ADDENDUM NO.: 03

PROJECT NAME: Design-Build Services for the City Colleges of Chicago School of Nursing Expansion at Kennedy-King

DATE OF ISSUE: November 15, 2024

Existing AHU

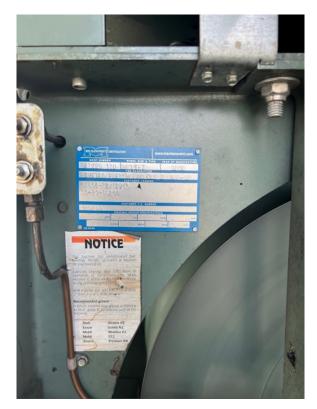
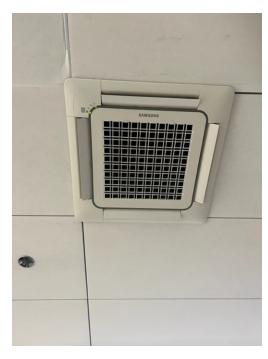
Question: Has the existing Air Handling Unit (AHU) on the roof been upgraded or replaced since its original

commissioning?

**Response:** The building includes the following equipment:

-One (1) Venmar rooftop AHU. Installed in 2007. Feeds the entire building. Includes AHU Fan Motor-

Baldor Serial No. C1710030717; Spec. 40G048X793.

-Two (2) Samsung ductless split system units (newer). Feed Math Emporium. Model: AJ036JCJ5CH.

-One (1) Liebert unit feeds the IT closet on the 1st Floor. Model #: PFH014A-PL3

Serial #: 0604N121260.

Refer to 'CCC School of Nursing Expansion at KKC Photos Document', dated November 14, 2024 for AHU unit, equipment tags, and rooftop conditions.
